MODIFICATION INSTRUCTIONS

KODAK MINILOADER 2 PLUS LOW VOLTAGE, MODELS STAND-ALONE, M35-M & 480RA

MODIFICATION No. M04

PURPOSE:

PCB 401

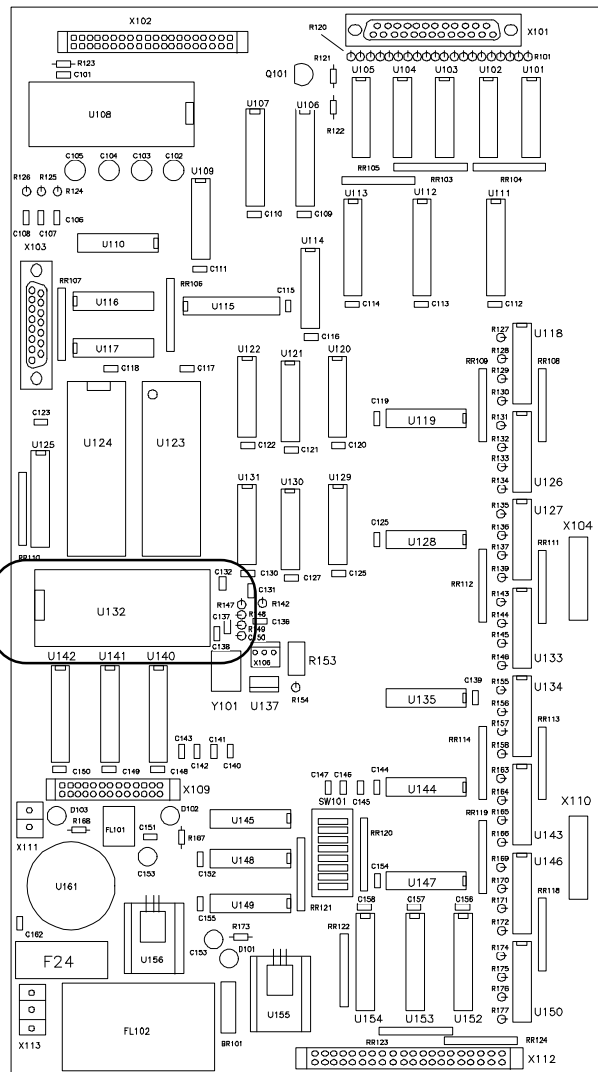
3. Switch off the MINILOADER, and remove the FRONT PANEL. When removing the FRONT PANEL make sure all LEADS are carefully disconnected.
4. Pull forwards the PCB 401/207 ASSEMBLY and remove the plastic PROTECTION COVER from the PCB'S.
5. Using the DRAWING on PAGE 4 identify the EPROM U132 on PCB 401. Using ESD precautions, remove the old EPROM and replace it with the EPROM in the MODIFICATION KIT.
